Bullock Creek School District
2024 Bond- Series 2 - 2027 Renovations
HS / MS / Floyd and Pine River Elementary Schools

ADDENDUM #1

Project: No. 26-210 Bullock Creek 2023 Bond Series 2
2027 Improvements

Issue Date: November 2, 2026

SEAL	DRAWN KRS	PROJECT NO. 26-210
	CHECKED JESS	CAD FILE NO. B-A103
	REVIEWED MLB	DRAWING NO. B-A103
	DATE OCT 19, 2026	SHEET NO. 4 OF 38
	SCALE AS NOTED

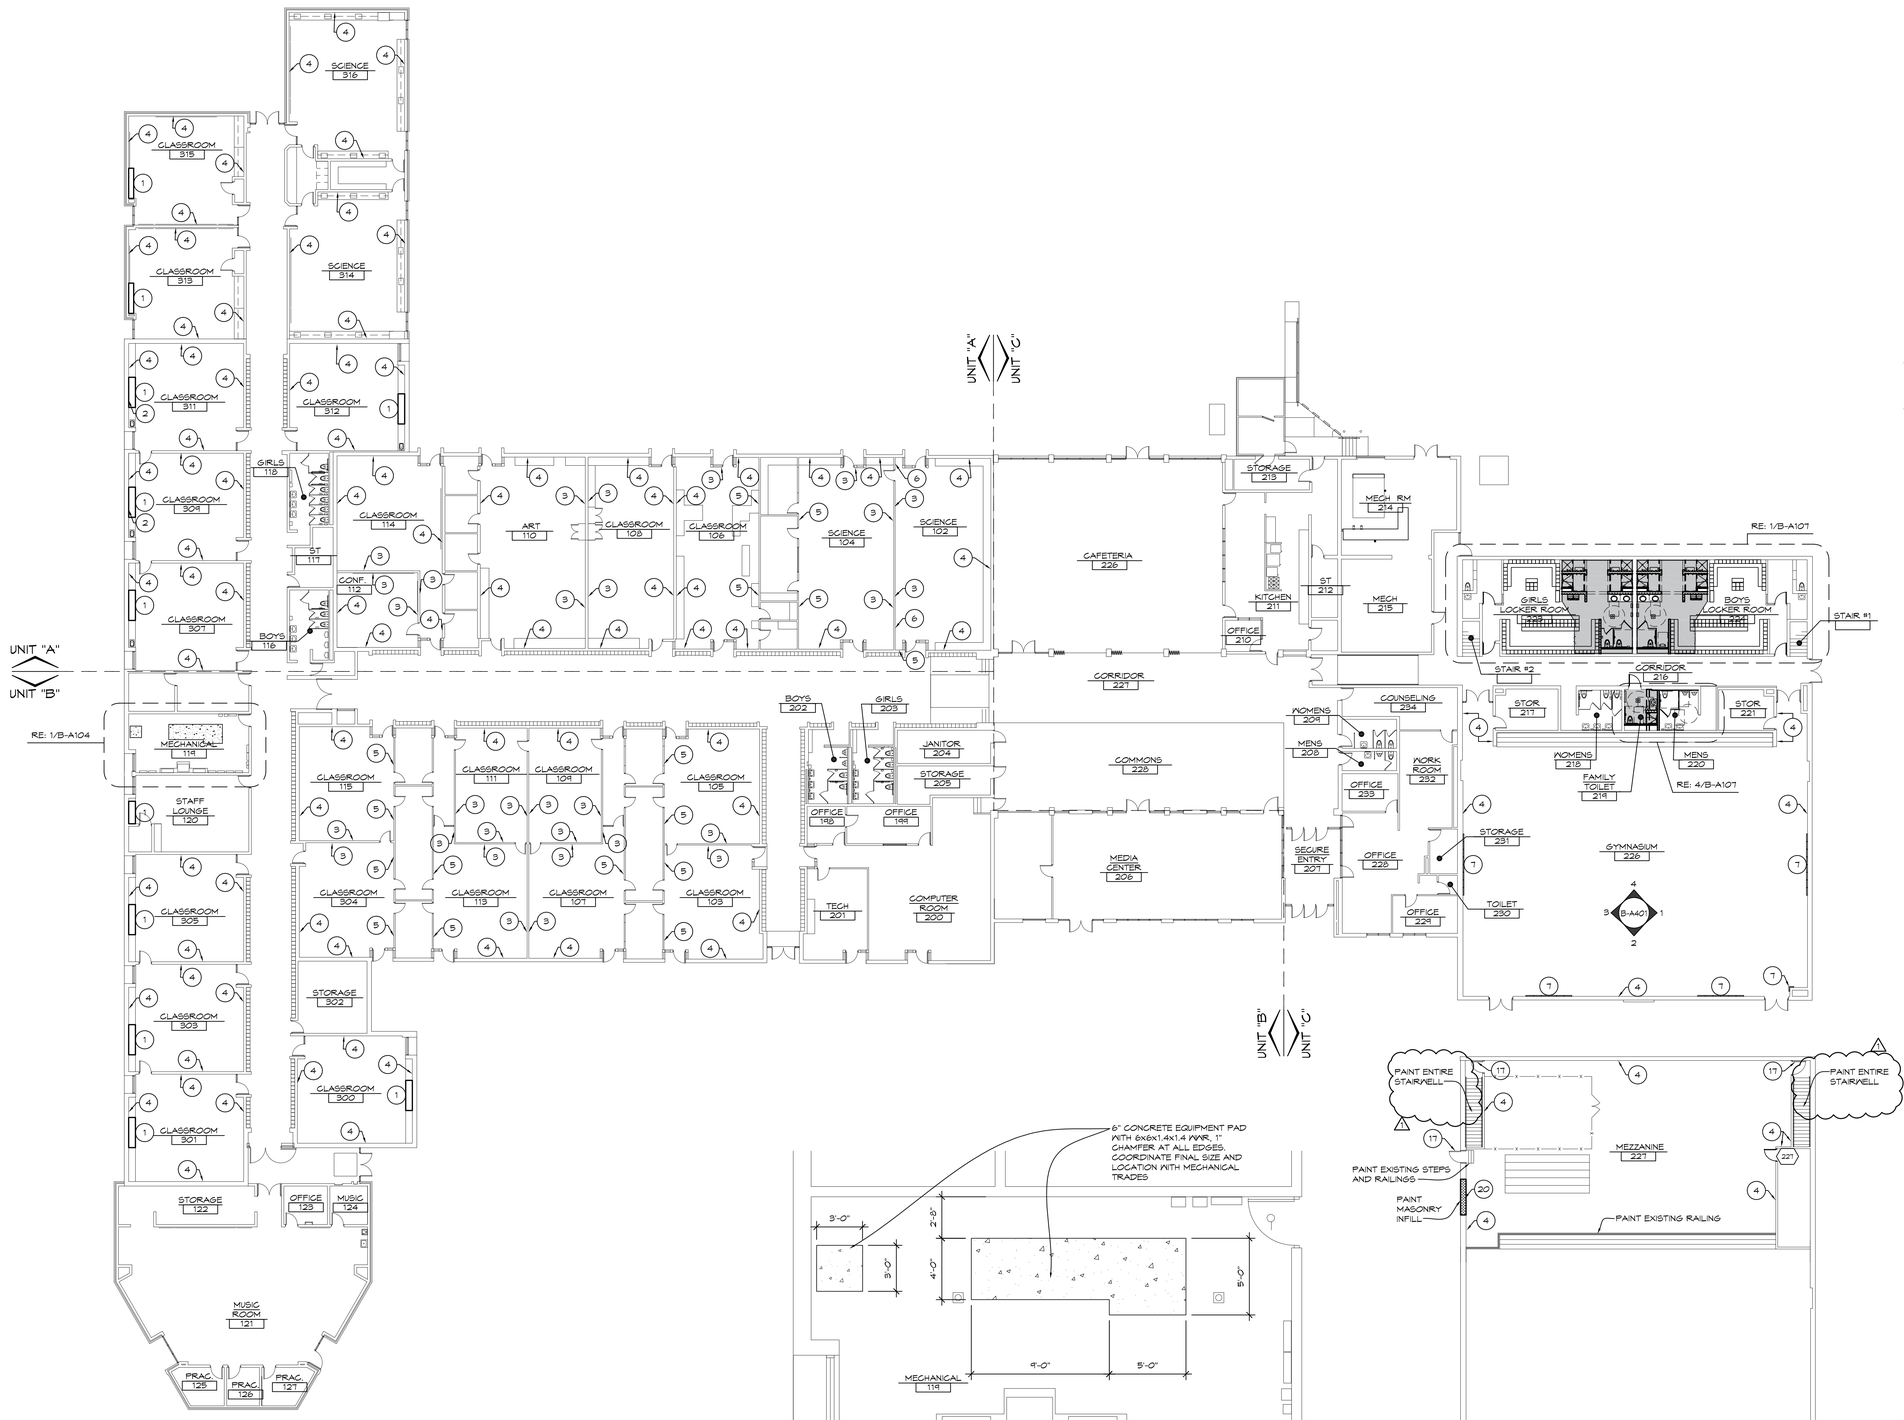
Item #A7: Revise Sheet B-A103 as follows:

a. Demolition Note 8 has been changed.
b. Note 14 has been added to Base Bid Enlarged Demolition Plan Rooms 222 and 225.
c. Note 17 is not used.
d. Note 20 has been added to Base Bid and Add Alternate #2 Enlarged Demolition Plans.
e. Note 20 has been added to Demolition Notes.
f. Note for door and frame removal has been changed on Base Bid Partial Mezzanine Demolition Plan 4/B-A103.

SEAL	DRAWN KRS	PROJECT NO. 26-210
	CHECKED JESS	CAD FILE NO. B-A104
	REVIEWED MLB	DRAWING NO. B-A104
	DATE OCT 14, 2026	SHEET NO. 5 OF 38
	SCALE AS NOTED

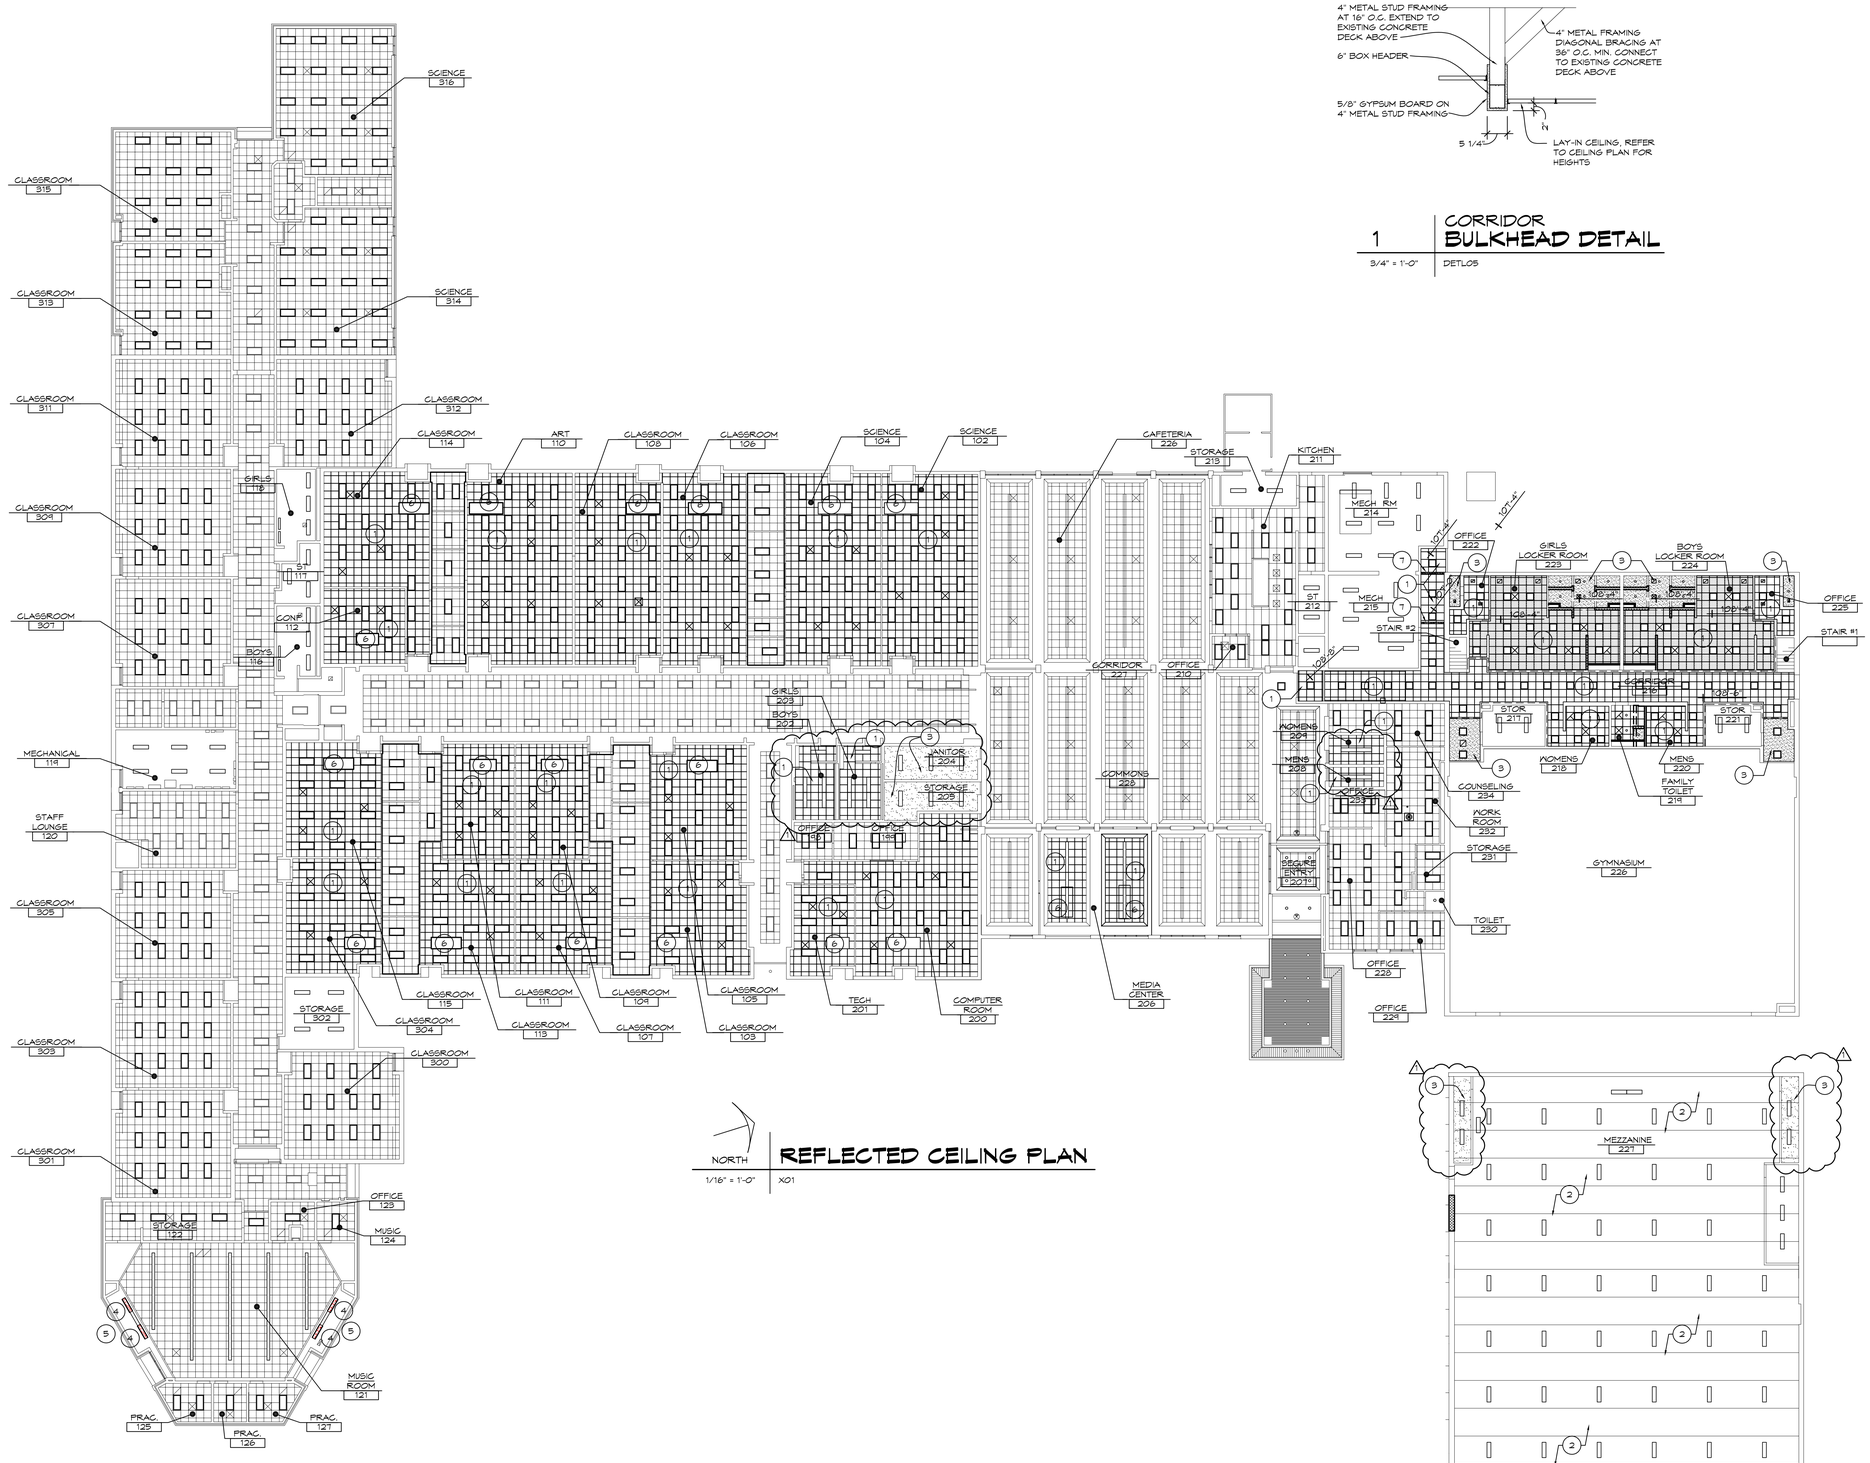
Item #A8: Revise Sheet B-A104 as follows:

a. Note to add painting to existing Stairwells has been added at two locations to Mezzanine Floor Plan.

SEAL	DRAWN CJV/KLS	PROJECT NO. 26-210
	CHECKED KLS	CAD FILE NO. B-M101
	REVIEWED MLB	DRAWING NO. B-M101
	DATE OCT 19, 2026	SHEET NO. 13 OF 36
	SCALE AS NOTED

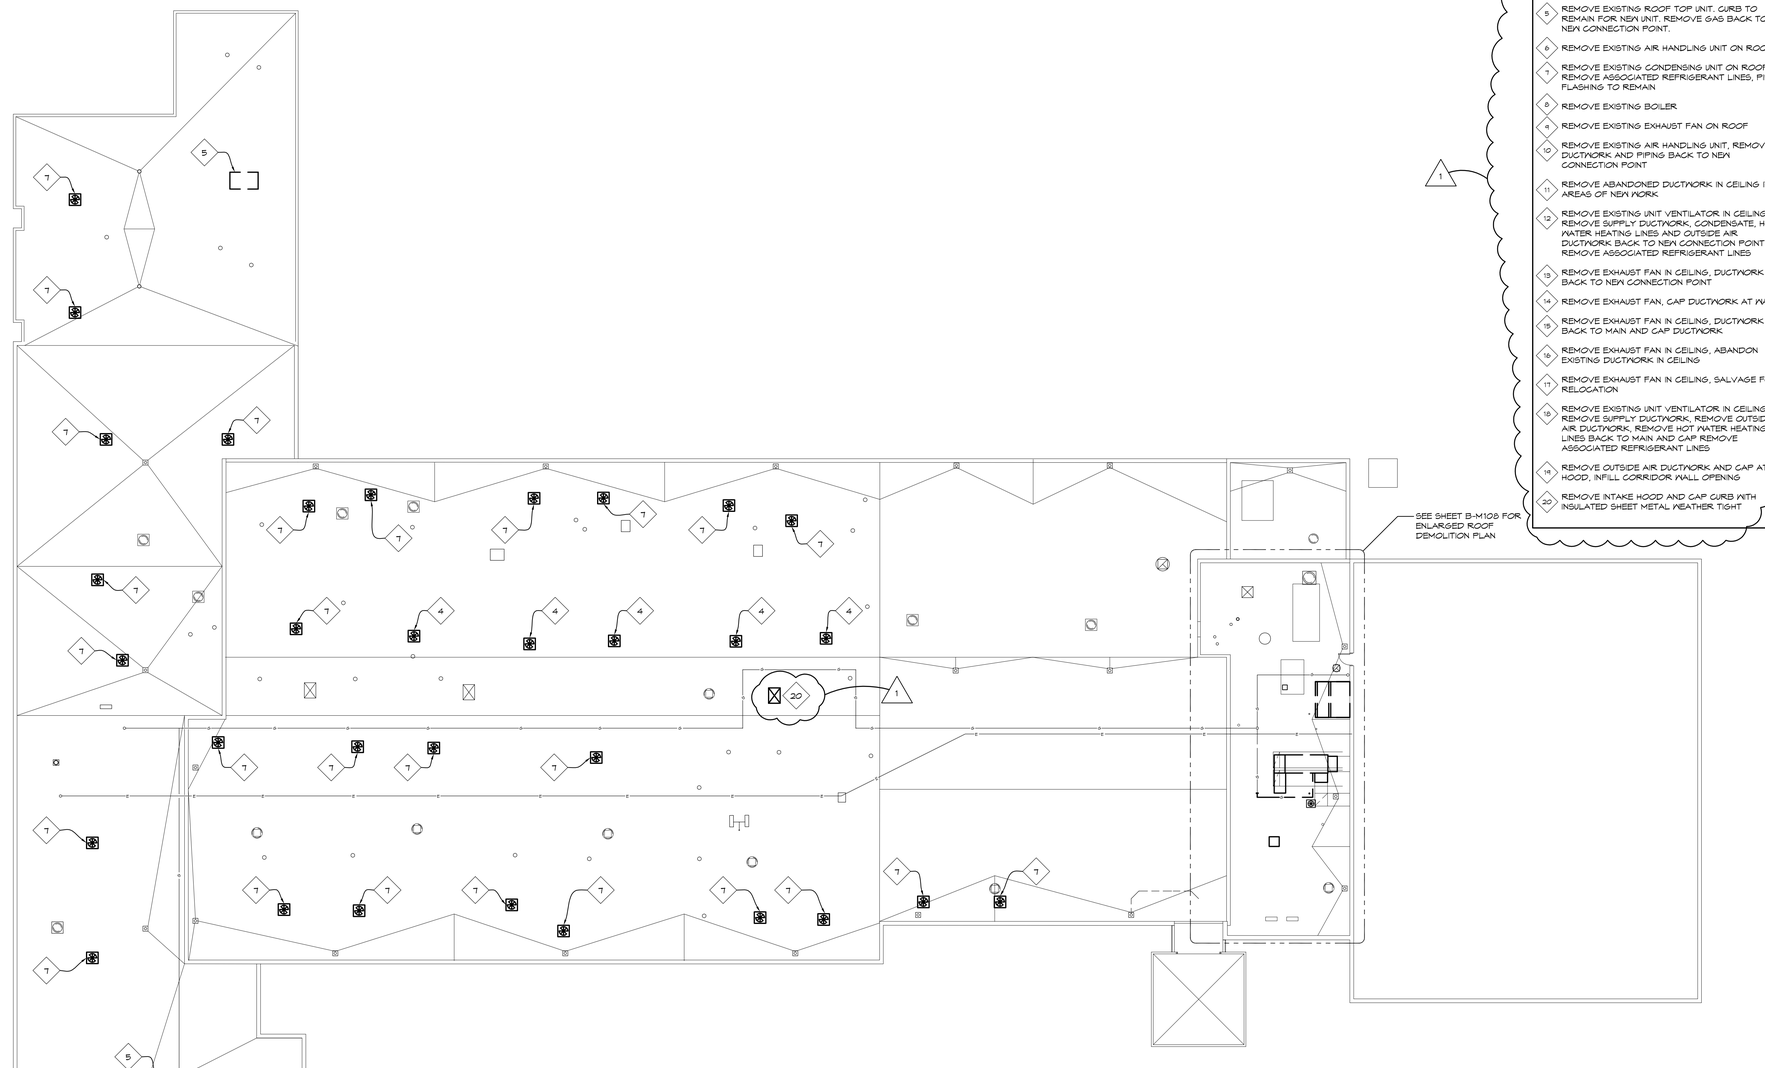
Item #M3: Revise Sheet B-M101 as follows:

a. General Note "ALL PIPING INSULATION TO BE REMOVED BY OTHERS" added to Plan.
b. General Note "ALL DUCTWORK INSULATION TO BE REMOVED BY OTHERS" added to Plan.
c. Added Note for relief hood to be removed on Roof in "Unit C", remaining ductwork to be abandoned in Ceiling Space.
d. Ductwork for Toilet Rooms in "Unit C" to be removed back to new connection point for exhaust discharge relocation.
e. Revised four Demolition Notes from Note 1 to 18 in "Unit B", added five Demolition Notes 19 in "Unit B" and one Demolition Note 20 in "Unit A".
f. Keyed Mechanical Demolition Notes revised. Notes 18,19 and 20 added, Notes 1, 2, 4, 5, 7, 12, and 15 revised.

SEAL	DRAWN CJV/KLS	PROJECT NO. 26-210
	CHECKED KLS	CAD FILE NO. B-M102
	REVIEWED MLB	DRAWING NO. B-M102
	DATE OCT 19, 2026	SHEET NO. 14 OF 38
	SCALE AS NOTED

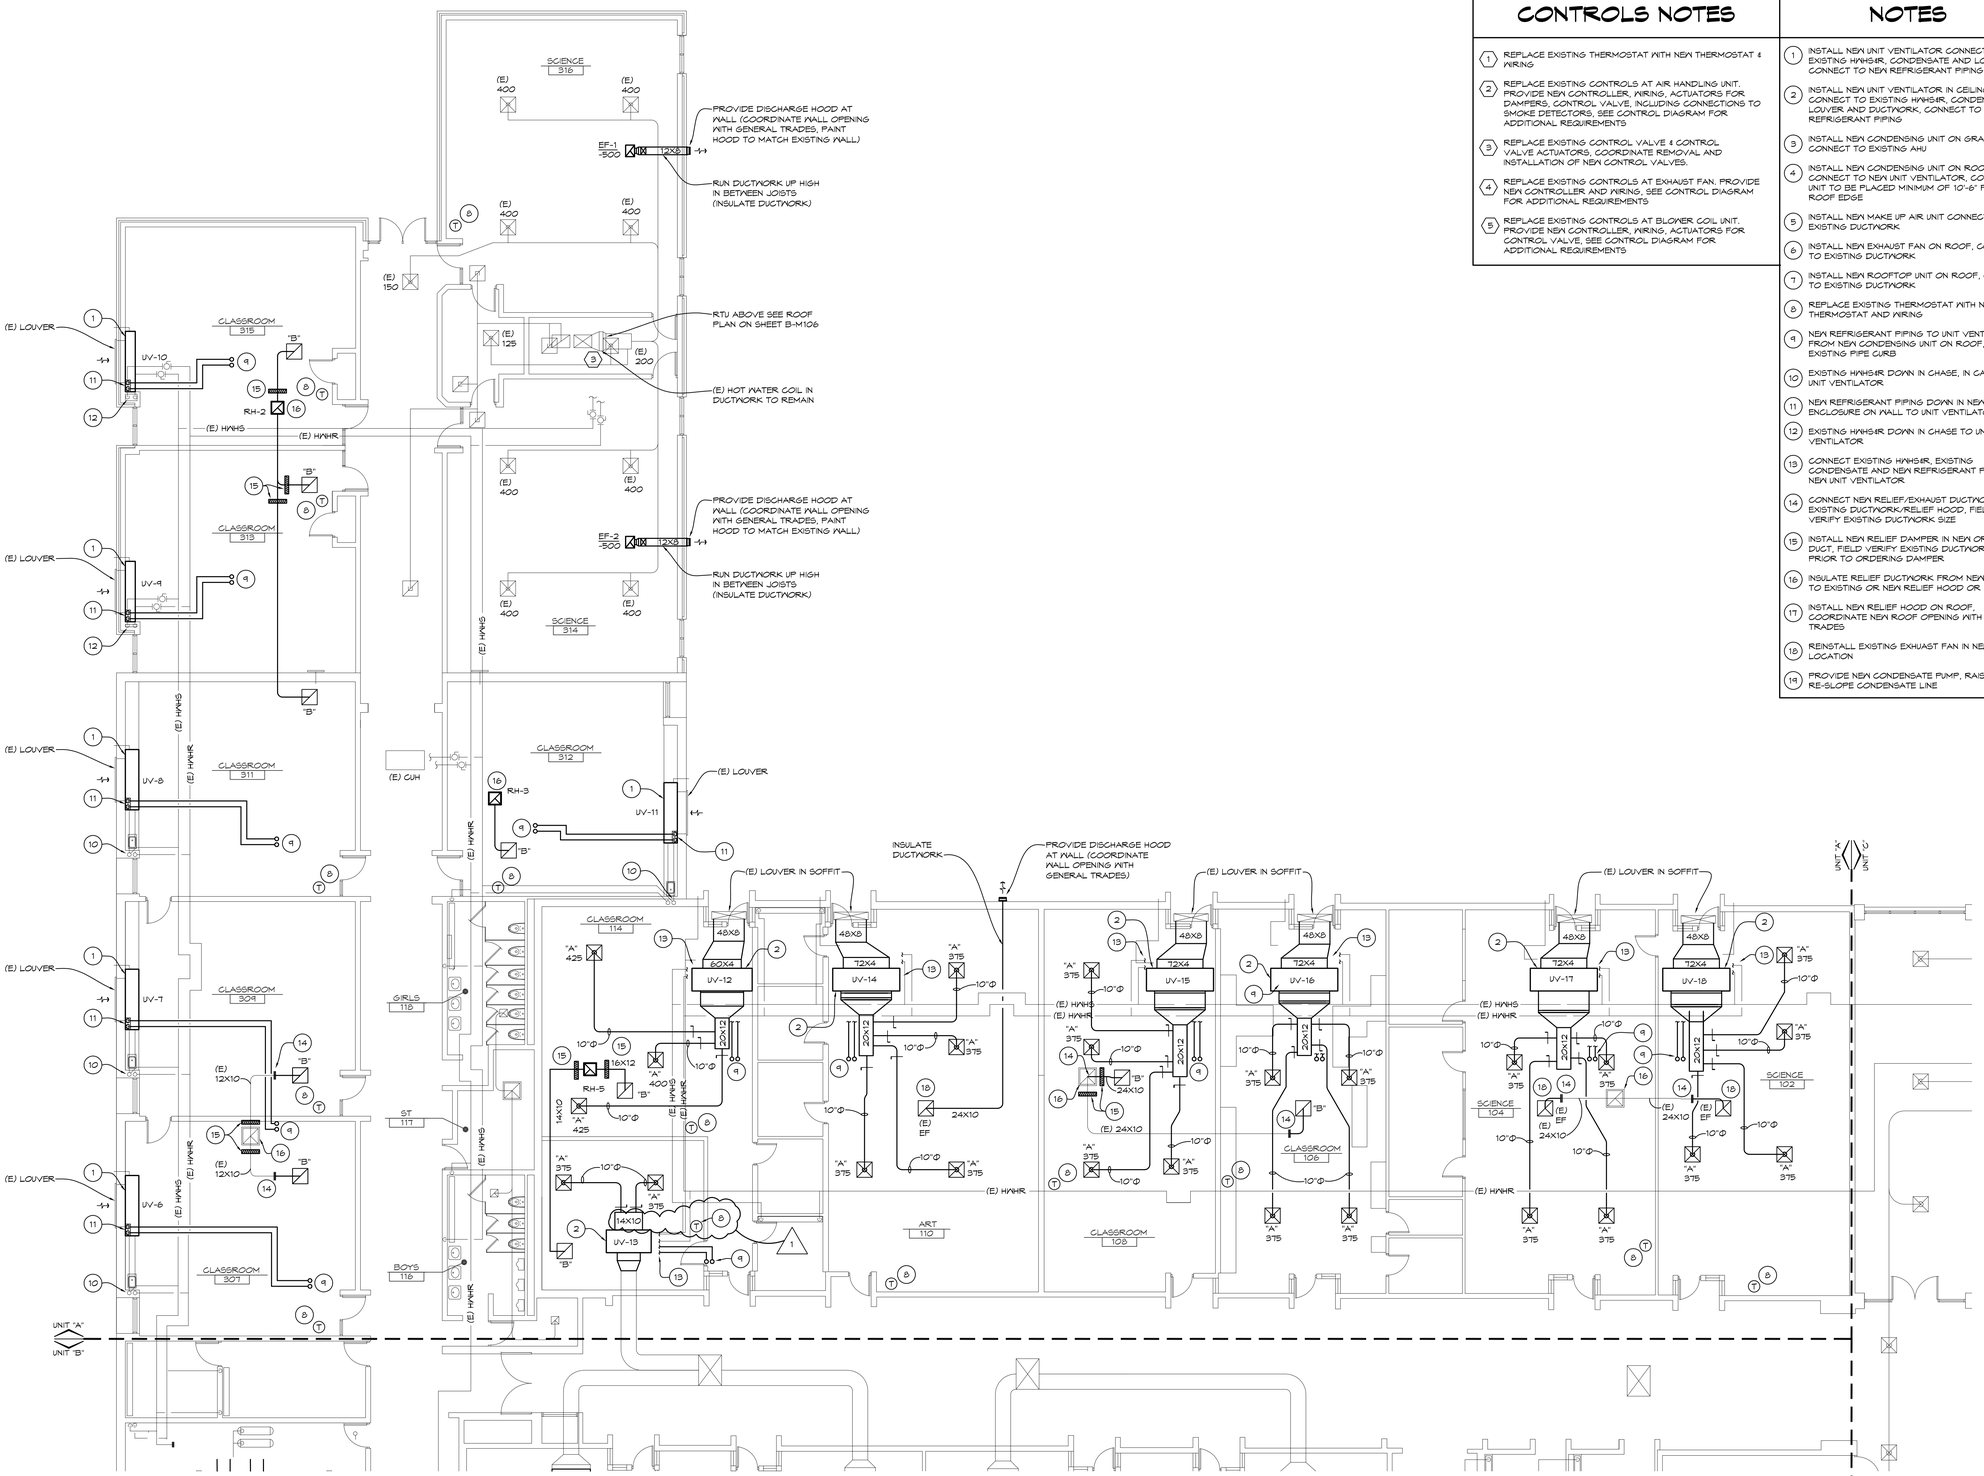
Item #M4: Revise Sheet B-M102 as follows:

a. Keyed Mechanical Demolition Notes revised. Notes 18, 19 and 20 added, Notes 1, 2, 4, 5, 7, 12, and 15 revised.
